CD 120 Conduit Bank Requirements

Conduit Bank Requirements

CD 120

Effective Date:
04-30-2021

Figure CD 120–1: Typical Conduit Bank Sections (Mainline and Commercial/Industrial)

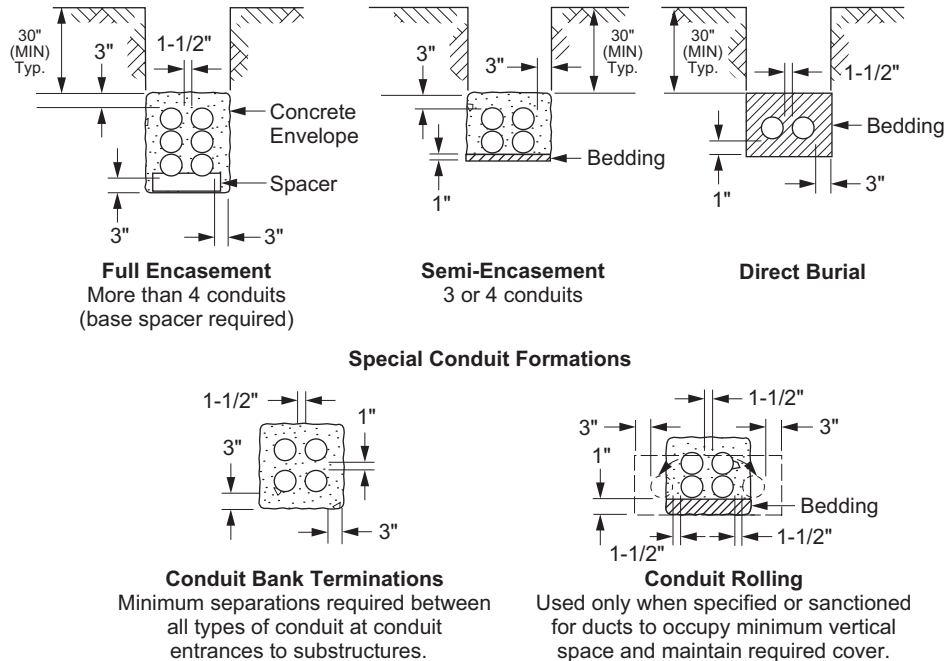
What's Changed? A minimum buried depth of 30-inches has been added to Figure CD 120-1 for clarity.
